UNITED STATES
DEPARTMENT OF THE INTERIOR
BUREAU OF LAND MANAGEMENTOCD-HOBBS
HOBBS OCDFORM APPROVED
OMB No 1004-0137
Expires: March 31, 2007SUNDRY NOTICES AND REPORTS ON WELLS
MAY 02 2012

OXY USA Inc. - Proposed
C.E. Lamunyon #79
API No. 30-025-35942

Permanent Abandonment of Federal Wells
Conditions of Approval

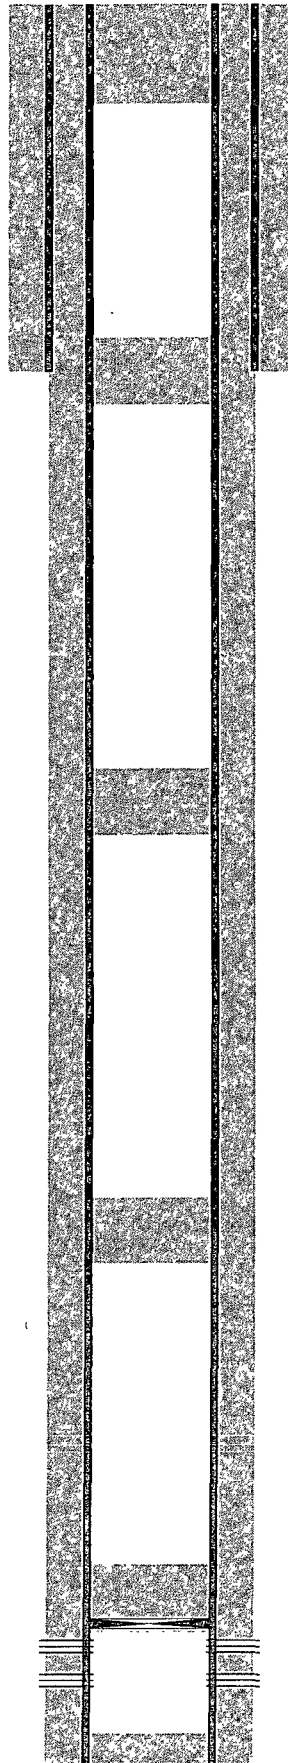
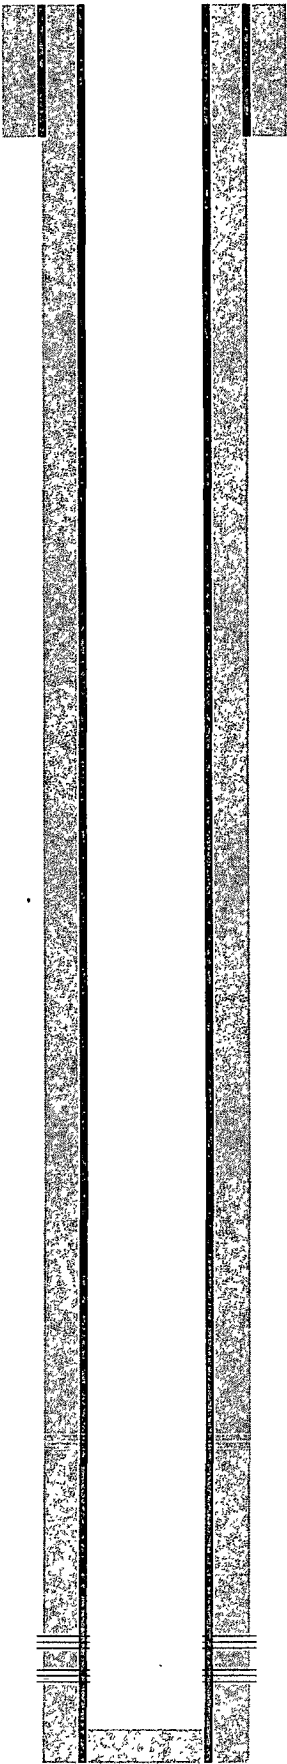
1226-1075 woc Tag

2585 - 24 60
WOC Tag

3850-3710

CIBAC 5075 cap w/ 255
TPC 4925
Paddock

SPECIAL: T/SALT 1174 +/-
B/SALT 2379 +/-
R III R
Cave/KARST

Considered B/salty	Area	1035
	Vates	2538
	7 Rivers	2795
	Queen	3067
	GB	3554
x	SA	3802
x	Glorietta	4951
	Paddock	5073
	Blincby	5296
